**BEFORE THE HEARINGS PANEL
FOR THE PROPOSED QUEENSTOWN LAKES DISTRICT PLAN**

IN THE MATTER of Hearing Stream 14:
Wakatipu Basin hearing
and transferred Stage 1
submissions related to
Arrowtown and Lake
Hayes

**STATEMENT OF EVIDENCE OF HELEN JULIET MELLSOP
ON BEHALF OF QUEENSTOWN LAKES DISTRICT COUNCIL**

LANDSCAPE

Figure 1: ONL boundaries east of Arthurs Point settlement. Boundary sought by Submitter #526 in green.

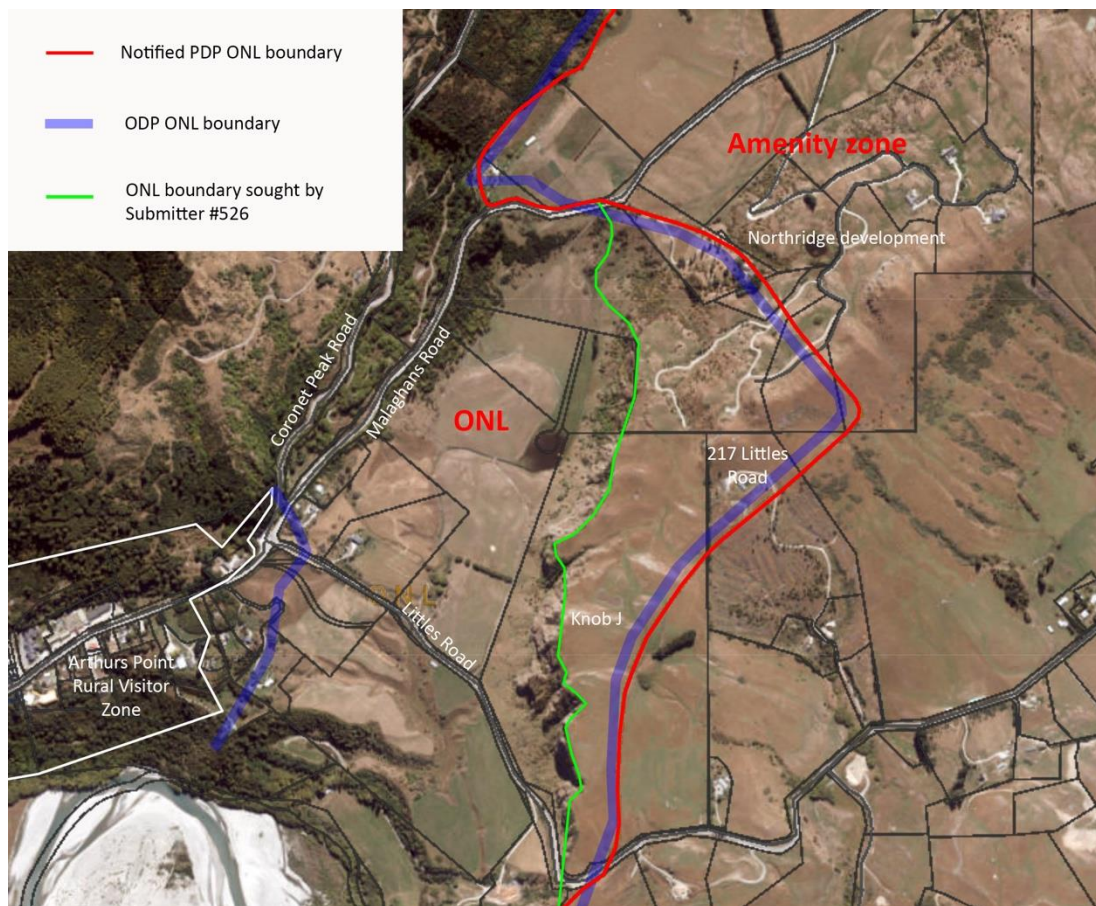
6.1 These three submitters all seek amendments to the boundary of the Arthurs Point Basin ONL around the western end of Littles Road. The submission of Shotover Hamlet Investments Limited is opposed by Robert Stewart (FS#1270). Alexander Reid has also sought rezoning of existing rural living development around the western end of Littles Road, from notified Rural to Rural Lifestyle. This land is located east of the Arthurs Point Rural Visitor Zone (in the ODP). The extent of the Rural Lifestyle zoning sought is unclear from the submission. Michaela Meehan has sought that the boundary of the ONL on the ridge east of the Littles Road/Malaghans Road junction be relocated west to the crest of the schist escarpment, while Shotover Hamlet Investments has sought that a small area of Rural Character Landscape (**RCL**) be designated between the Arthurs Point Rural Visitor Zone and Littles Road (see discontinuous blue line on Figure 1 below).

- 6.4** In paragraphs 5.4.1 to 5.4.3 of the Landscape Boundaries Report, the discontinuous line drawn on the ODP landscape classification maps following Environment Court decision C3/2002 is discussed. The area between this line and the ODP Arthurs Point Rural Visitor Zone is the land that Shotover Hamlet Investments Limited seeks to be classified as RCL. I am in complete agreement with Dr Read's discussion of this issue in the Landscape Boundaries Report – I consider a discontinuous line is highly problematic from a landscape assessment perspective and would define an area that is too small to form a landscape in its own right. While the area has been domesticated by dwellings, driveways and rural living activities, it forms a small landscape unit within the wider ONL of the Arthurs Point basin.

- 6.5** Given that I consider the land at the western end of Littles Road to be within an ONL, I do not support the Rural Lifestyle zoning of this area sought by Mr Reid. Additional rural living development within this area is unlikely to maintain or enhance the character and values of the ONL.

- 6.6** Consequently I oppose the relief sought by Submitters #277, #526 and #570.

Figure 2: notified PDP and recommended ONF boundaries in north-eastern corner of Threepwood.

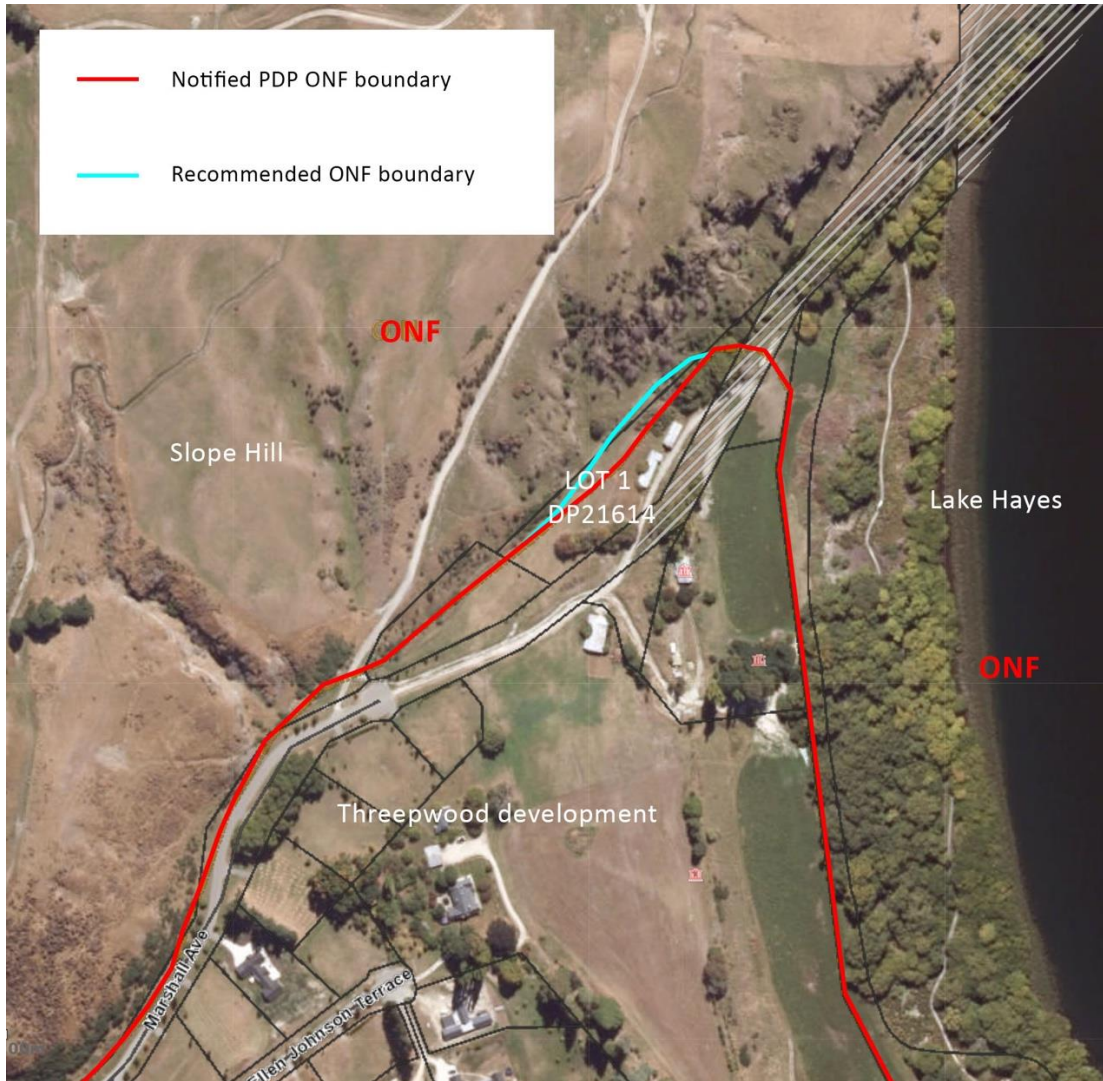
- 6.8** Having visited the site, I agree that the toe of Slope Hill lies largely outside Lot 1 DP 21614, roughly following an old track at the base of hill. However in my assessment the ONF boundary does enter the north-western part of the lot, where the toe of the hill crosses the property boundary. The notified and recommended ONF boundaries are shown in Figure 2 below.

Figure 4: ONF boundaries on the south-west and west sides of Slope Hill. Boundary sought by submitters in green.

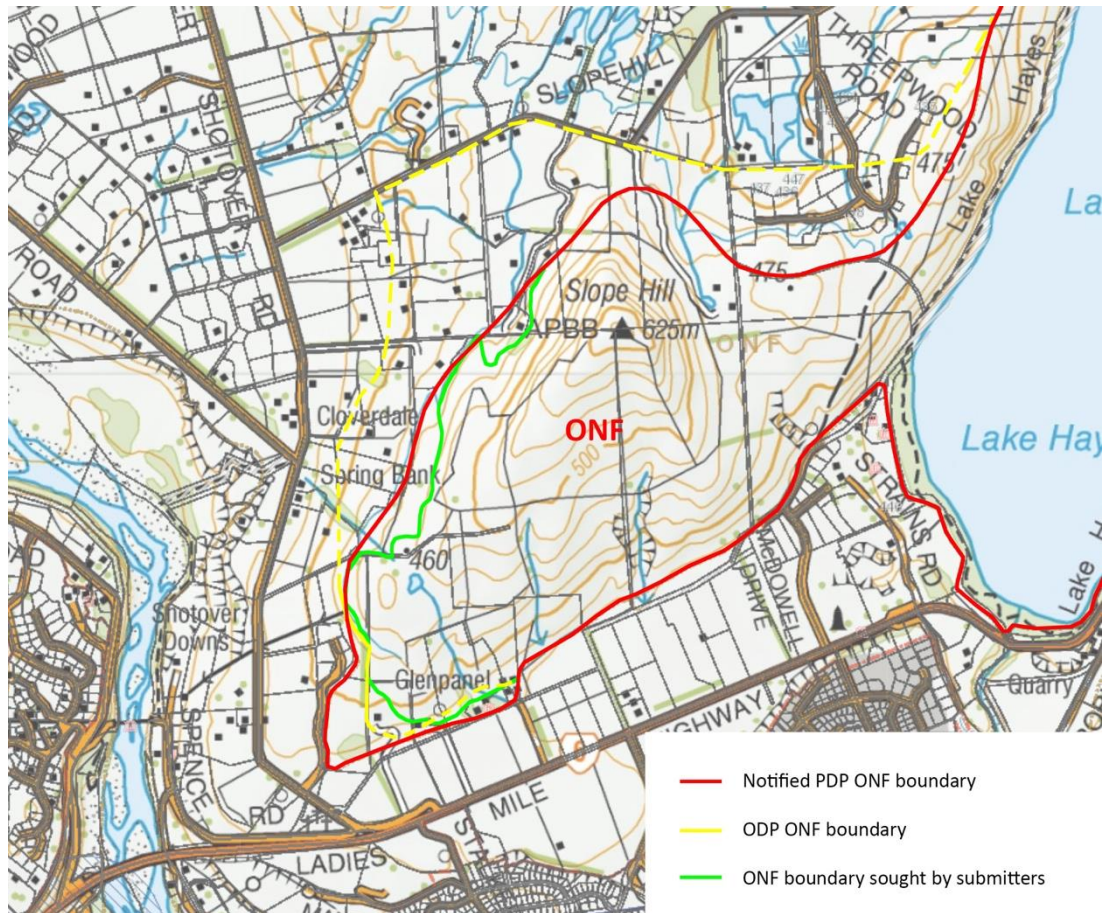
- 6.18** In the Landscape Boundaries Report, Dr Read accepted the south-west boundary approved by the Environment Court, but recommended modifications to the indicative line further north and parallel to Lower Shotover Road, around the northern extent of Slope Hill, and at the southern extent near Glenpanel.¹¹ These recommendations were endorsed by Mr Ben Espie in his review of the landscape boundaries report.¹² However the line shown in Figure 49 of the Landscape Boundaries Report and in the notified PDP maps differs slightly from that described in C216/2001 on the south-west side of the hill (refer Figure 4 below), as it does not follow the hawthorn hedge up the slope

- 6.20** Having assessed the character of the landscape in the areas between the notified boundary and that sought by submitters, I agree with the submitters that the ONF boundary should exclude the Glenpanel homestead and curtilage and the dwellings at 399 Frankton Ladies Mile Highway and 14 Lower Shotover Road. The Glenpanel homestead and curtilage is largely on the flats rather than the hill slope and is included within the indicative boundary of the potential Ladies Mile Special Housing Area in the QLDC Housing Accords and Special Housing Areas Act 2013 Implementation Policy, dated 29 October 2017. The dwellings and associated development and domestic planting at 399 Frankton Ladies Mile Highway and 14 Lower Shotover Road are clearly located within the topographical feature of Slope Hill. However this is also true of rural living development on the western slopes of the hill.

6.22 Further north on the western side of Slope Hill I consider that the notified ONF boundary is appropriately located and provides a clear boundary between the more developed lower slopes and the more open and elevated upper slopes (refer Figure 4 above).

6.23 I therefore agree with the amendment to the ONF boundary sought by submitters in the Glenpanel/Springbank area (shown in green in Figure 5 below), but oppose the other amendments sought by the submitters.

Figure 6: Notified PDP and recommended ONL boundaries on Lot 403 DP 379403.

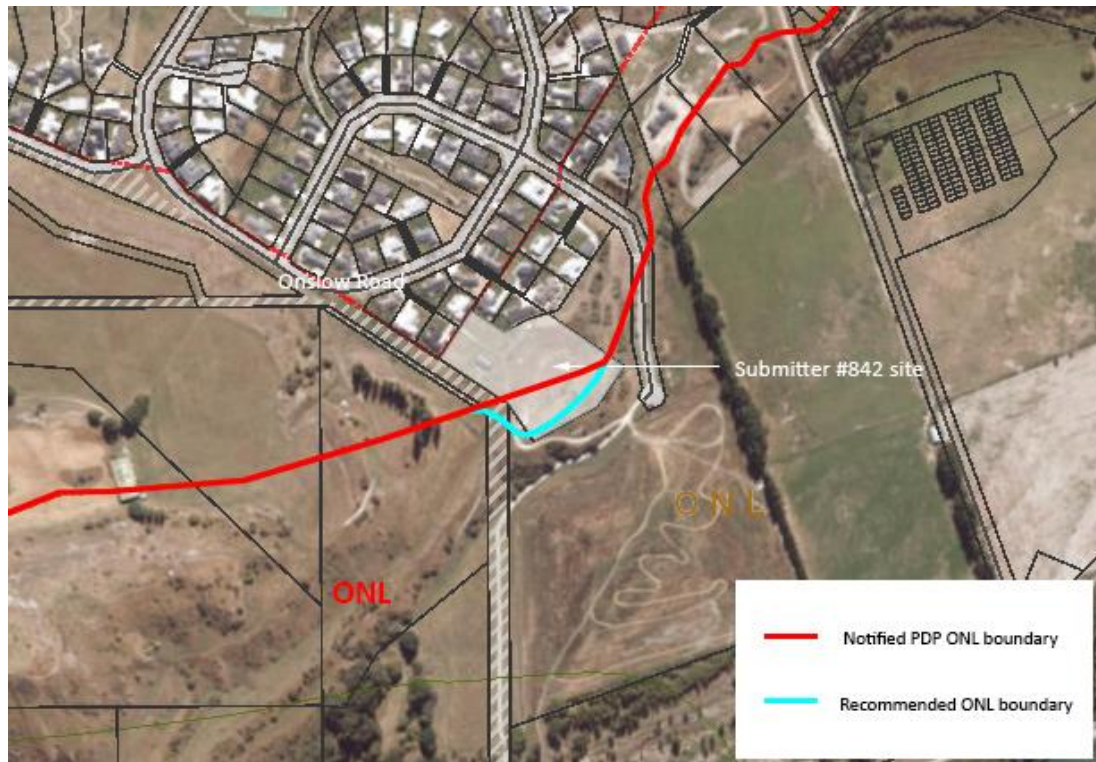
- 6.42** Lot 403 DP 379403 is located on the eastern side of the end of Onslow Road. Consent for subdivision of the site into 21 vacant lots of between 340 and 1090m² in area was granted as part of SH160140, a consent granted under the HASHA. The notified ONL boundary runs through the subdivided area and includes 5-6 lots within the ONL. As a result of historic earthworks on the site, I consider the ONL boundary is more

appropriately located at the crest of the bund south of the residential lots (refer Figure 6 below). This now forms the effective crest of the river escarpment.

Figure 7: Notified PDP and recommended ONL boundaries in the vicinity of Lots 1 and 2 DP 476278.

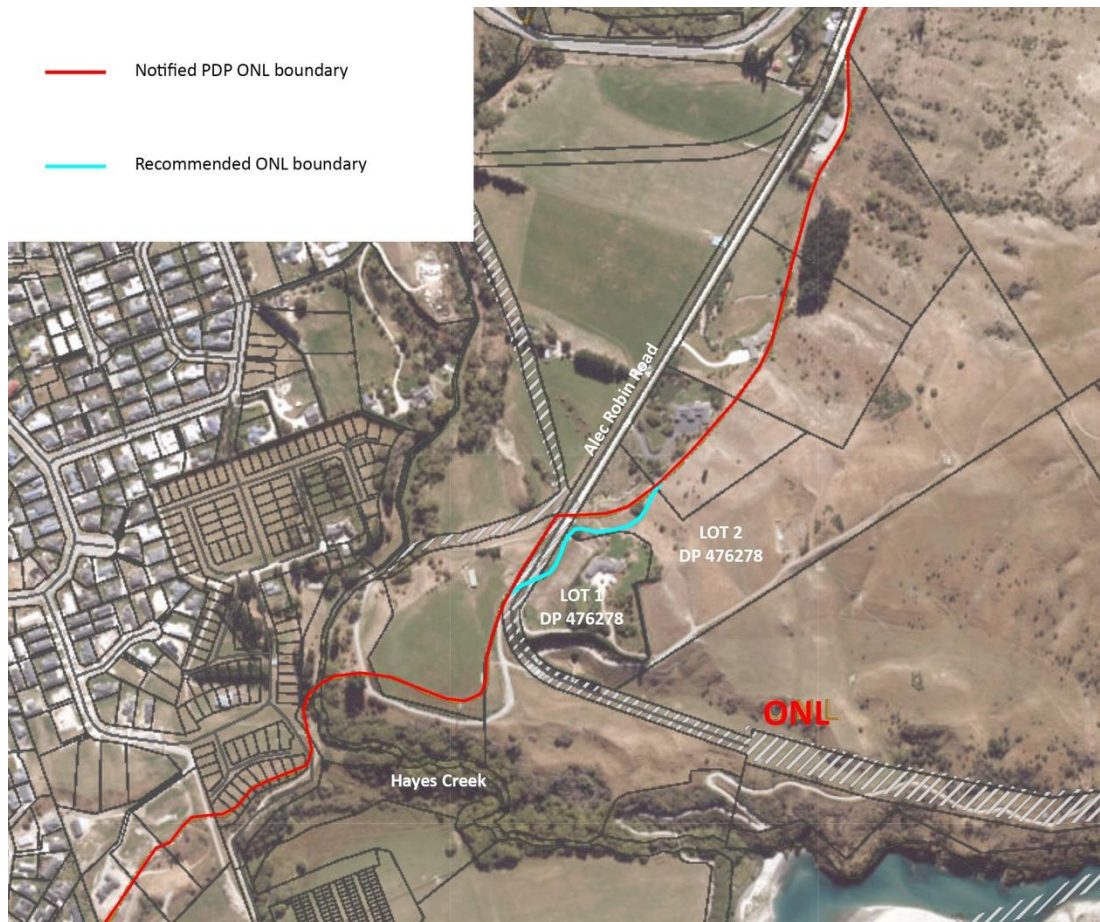
- 6.46** It is however clear from the Appendix 8A map that, in the vicinity of the submitter's property, the boundary is intended to cross Hayes Creek from the west, to run along the crest of the escarpment that encloses the Kawarau River valley and to then to follow the base of the Morven Hill roche moutonnée where there is a clearly legible change in gradient. In my assessment the boundary included in the notified PDP maps accurately follows this legible topographical boundary, except in relation to Alec Robins Road. To achieve consistency with the topography, the line should cross the road reserve diagonally to reach the eastern side of the road just south of the driveway entry to 111 Alec Robins Road (refer to Figure 7 below). I therefore oppose the relief sought in part.

Figure 9: ONL boundaries on the eastern side of Morven Hill.

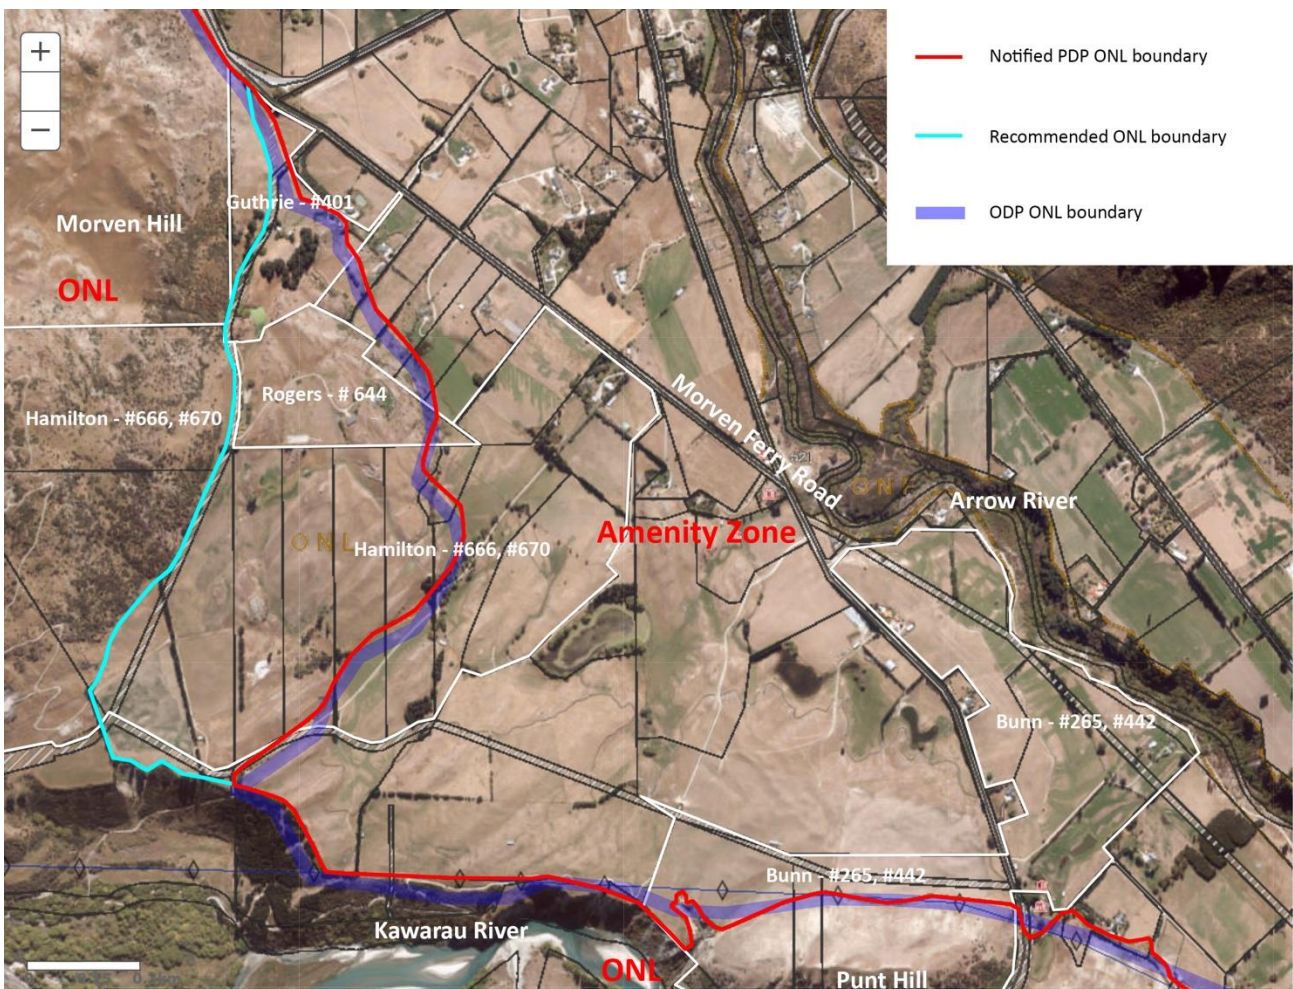
6.68 These submitters have all sought amendments to the location of the ONL boundary on the eastern side of Morven Hill within the Guthrie, Rogers and Hamilton properties (refer Figure 9 above). Mr Guthrie has also sought rezoning of his land from Rural (partly Amenity Zone in notified Stage 2) to Rural Residential, while submitters #664, #666, #670 and #690 have sought rezoning of the Hamilton property from notified Rural and Amenity Zone to an undefined mixture of Rural Lifestyle and Rural Visitor zone. The ONL boundary submissions #670 and #690 are supported by a further submission from Anna-Marie Chin (#1310), although this submitter opposes the rezoning sought for the land.

6.75 In order to ensure consistency in the application of the landscape classification process and to ensure that landscape units of similar character have the same classification, I recommend that the plateau and escarpment east of Morven Hill be included in the wider ONL landscape to the east and north that is proposed to be zoned Amenity Zone. The boundary of the ONL would align roughly with the change of gradient at the eastern toe of Morven Hill (refer Figure 9 on page 32 above). This change in gradient follows the Arrow irrigation race from SH6 across the northern part of the Guthrie property to reach the legal road designation, then along the western side of the legal road as far as a north-south oriented pine shelter belt on the Hamilton property. From there the change in gradient diverges from the legal road to follow the paddock fence line to the next north-south pine shelter belt, and follows this line of trees down to reach the crest of the Kawarau River escarpment.

Figure 10: ONL boundaries in the northern Crown Terrace. Boundary sought by Submitter # 459 in green.

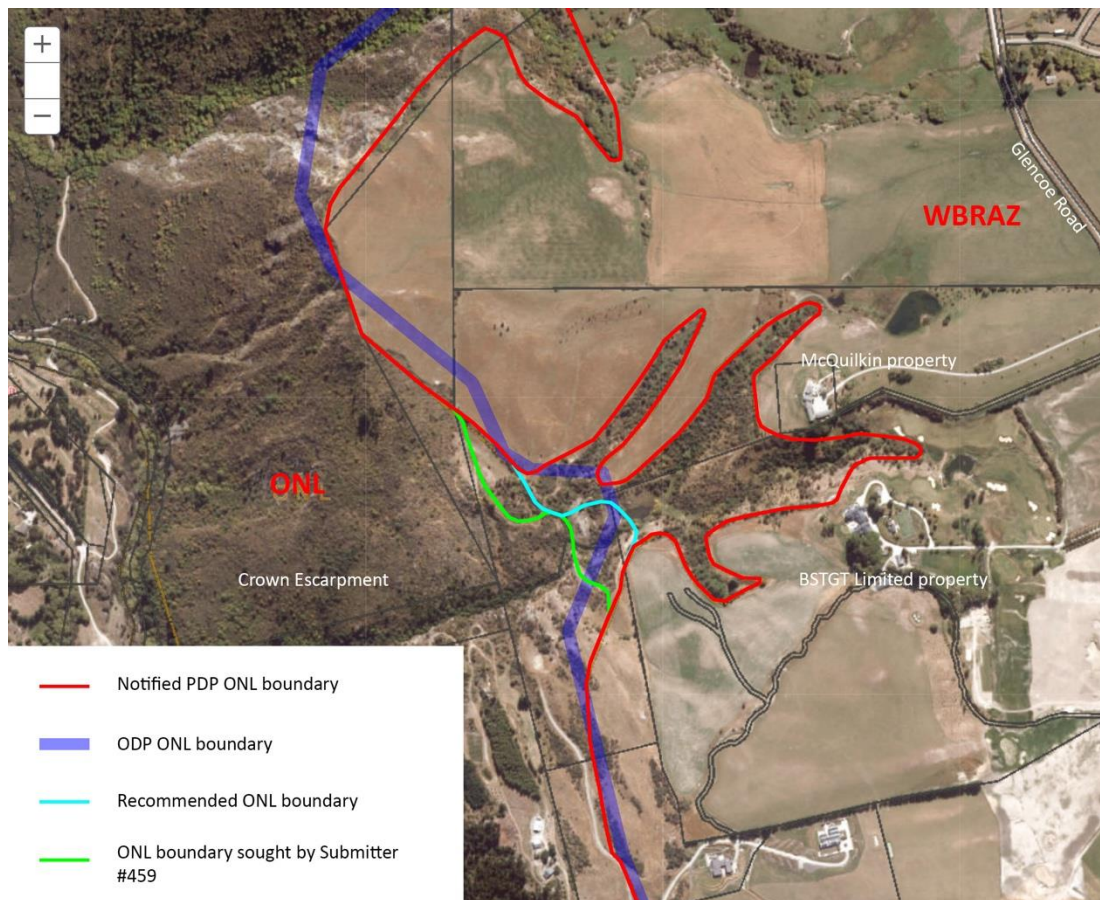
6.79 Tony McQuilkin and BSTGT Limited (FS#1122 and #2487) have sought that the notified PDP boundary of the Crown Escarpment ONL be amended in relation to their adjacent properties, which are at 141 and 117 Glencoe Road. A map of the proposed amended boundary is attached to Mr McQuilkin's submission and this line has been included in Figure 10 below.

6.82 Having visited the site, analysed the landscape characteristics and values, and considered the C87/2002 decisions, I recommend that the ONL boundary be amended to the turquoise line in Figure 10 above. My reasons are:

- (b) The lower part of the stream gully, before it descends steeply down the escarpment, is deeply incised and includes a number of distinctive ridges and outcrops of exposed schist (refer Photograph 9 below), as well as gold mine tailings (see Photograph 10 below). While this area has been modified by historic gold mining, this cultural heritage contributes to the landscape significance of the gully; and

- (c) Above the recommended landscape boundary, the gullies are either considerably modified (by a man-made pond and other structures in the case of the BSTGT Limited main gully) or form 'waterways running through a farming landscape'.

Figure 11: ONL boundaries in the northern Crown Terrace. Boundary sought by Submitter # 459 in green.

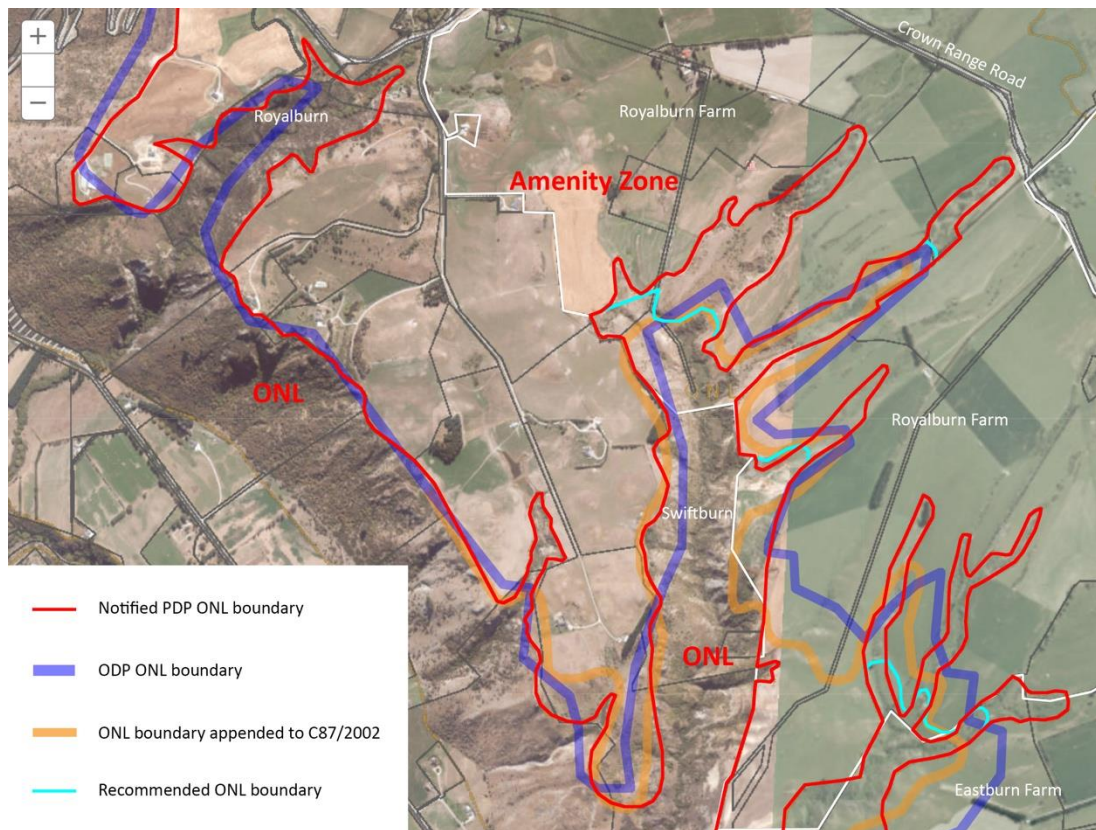
6.85 As can be seen in Figure 11 below, the ODP ONL boundary and the C87/2002 boundary do not align in many places on Royalburn Farm. Both lines were drawn by hand on a topographical map and have a thickness of between about 30 and 50 metres on the ground. The notified PDP line has been refined to more closely follow the actual

topographic boundary between the gullies of the Swiftburn tributaries and the surrounding working farmland. The notified PDP boundary does however extend further up the tributary watercourses than the C87/2002 decision. Following an on-site assessment and analysis, I consider that the upper 'fingers' of ONL that extend towards the Crown Range Road form 'waterways within a working farm landscape' rather than part of the Swiftburn gorge ONL. I have recommended appropriate locations to truncate these 'fingers' in Figure 11 below. These locations are based on the depth, steepness and natural character of the gullies, together with the current extent of cultivated farm paddocks adjacent to them.
